AGENDA FOR REGULAR MEETING VILLAGE OF TINLEY PARK PLAN COMMISSION

ITEM#1 PUBLIC HEARING – FLOOR & DÉCOR REDEVELOPMENT, 7061-7063 159TH STREET – ARCHITECTURE/SITE PLAN APPROVAL AND SIGN VARIATION

PLAN COMMISSION STAFF REPORT

Changes to the May 20, 2021 Plan Commission Workshop Staff Report are indicated in RED.

RECOMMENDATIONS (MATCH FINISH COLOR). FLOOR AND DECOR TO FINISH PAINT THE ENTIRE REAR WALL. REAR ELEVATION

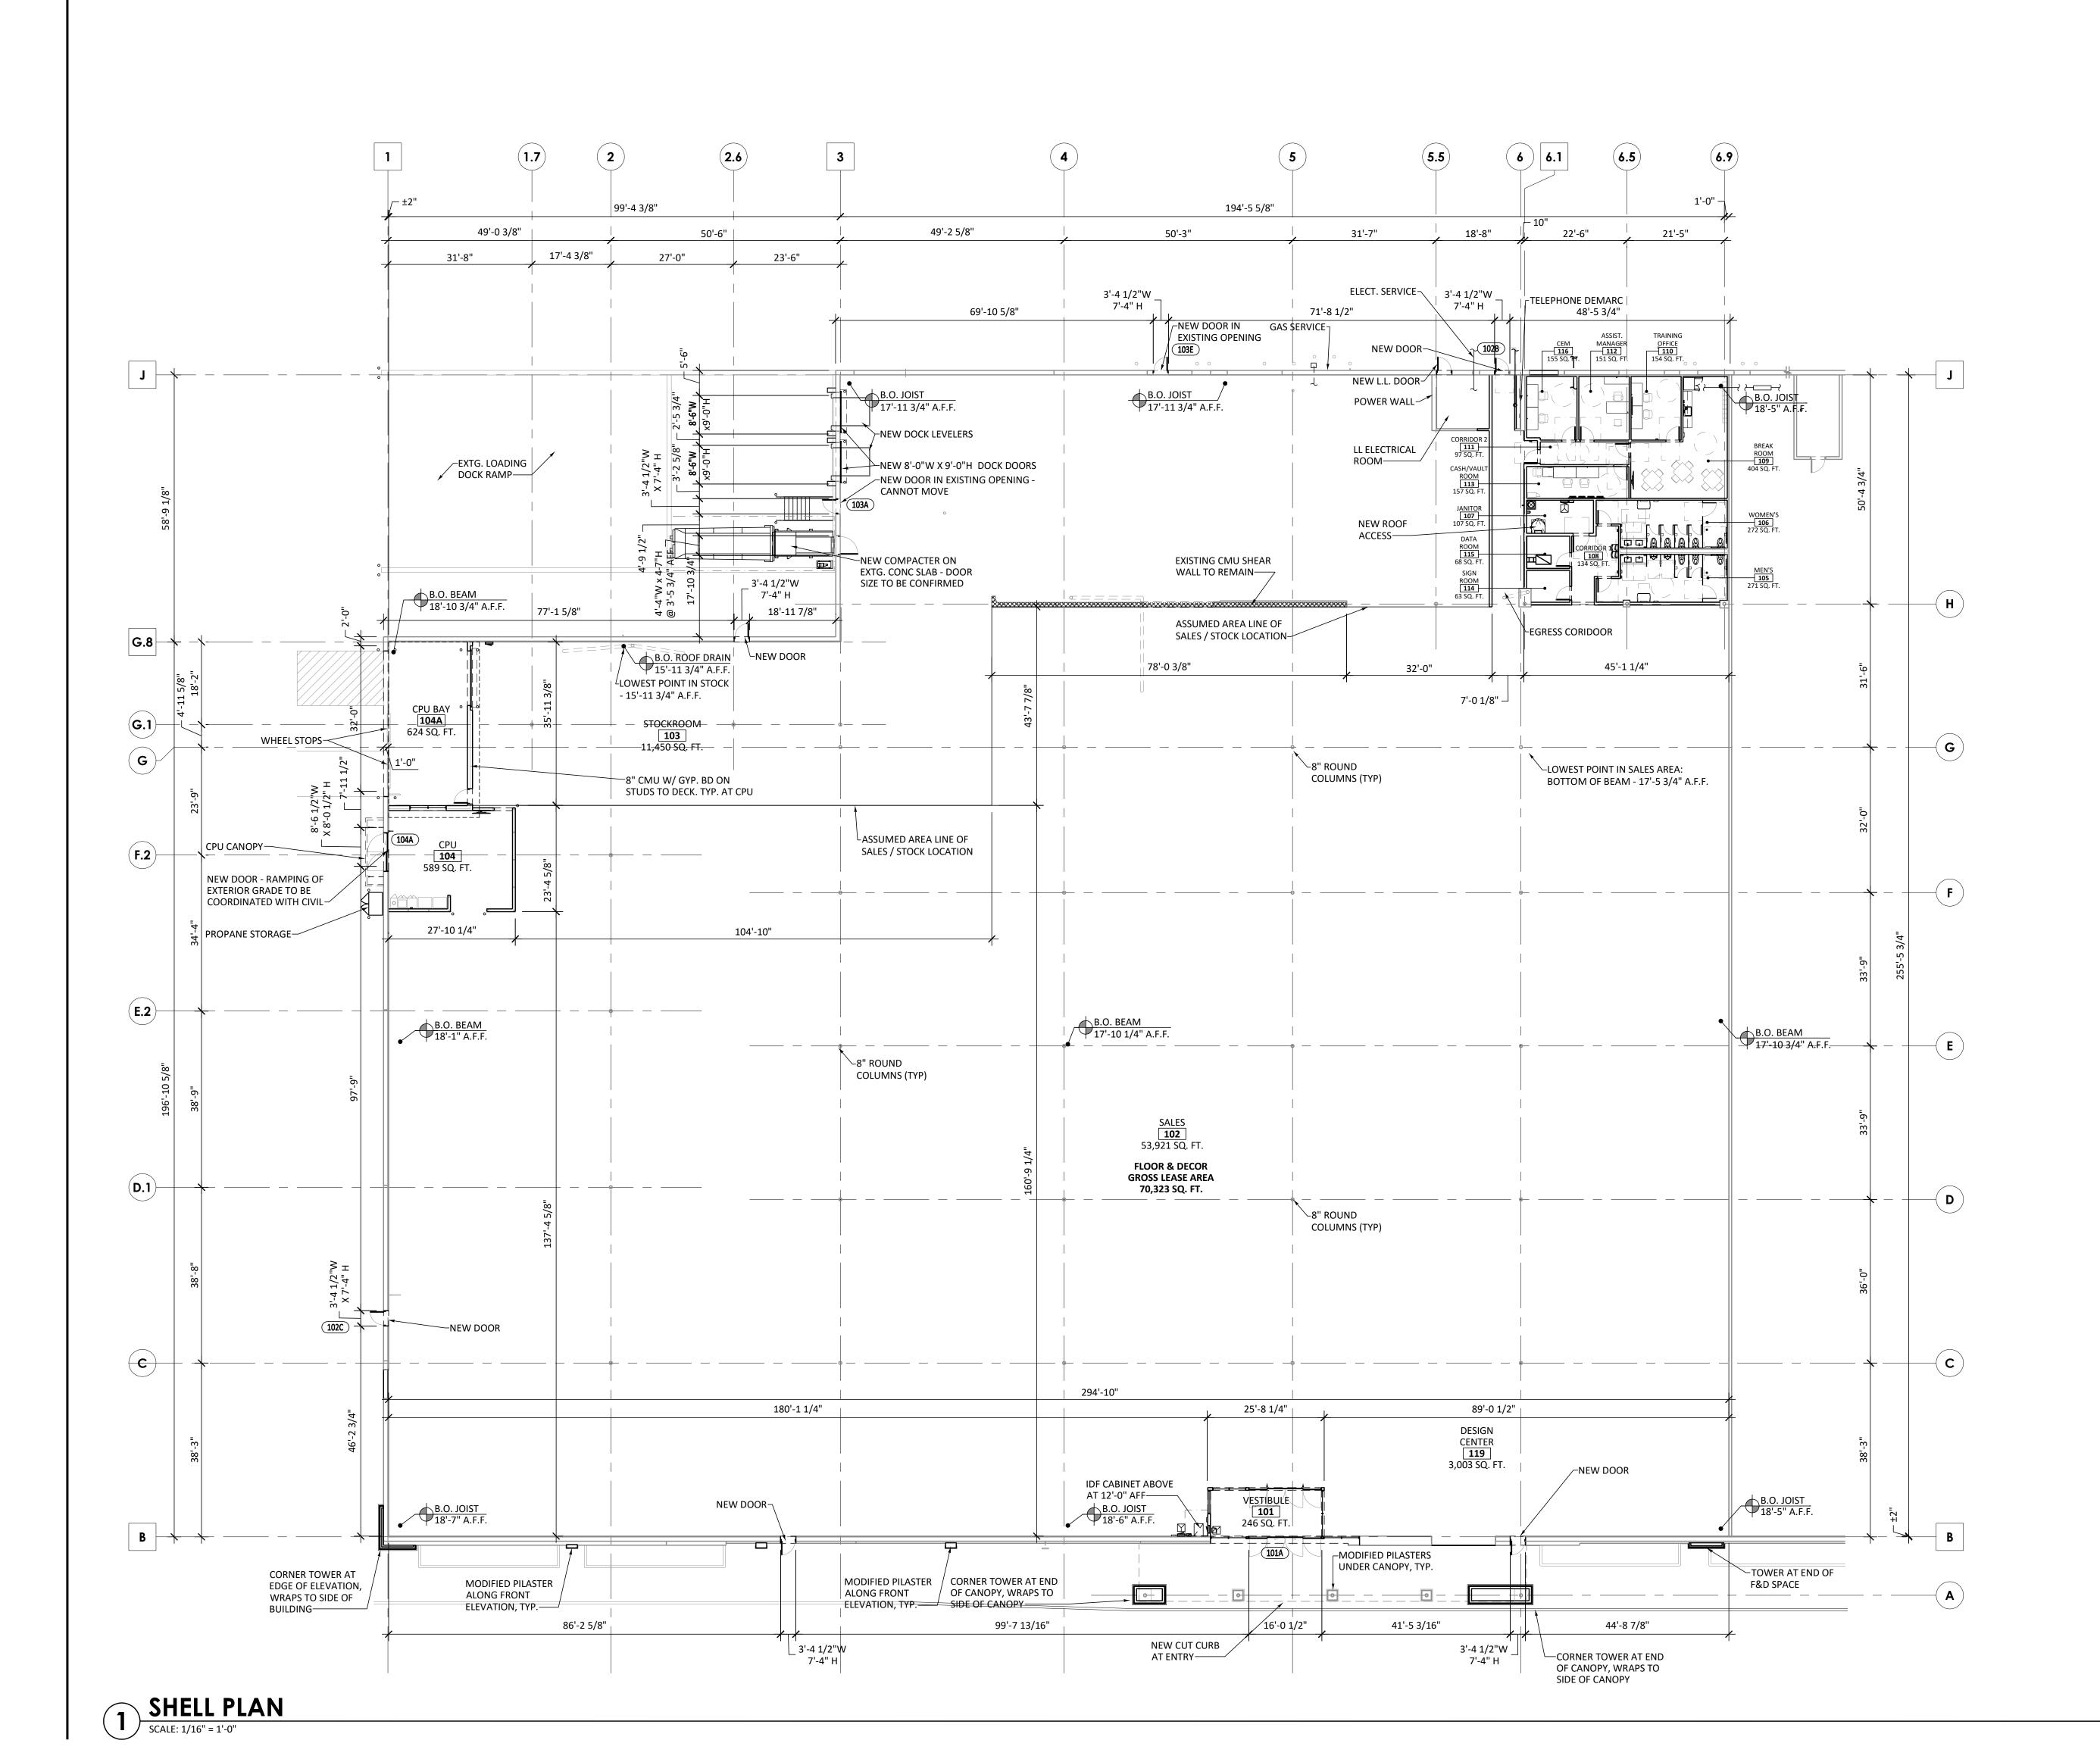
A recommended condition has been added to require complete painting of the entire rear façade at the same time and in one color/shade to be completed with the Phase 1 work.
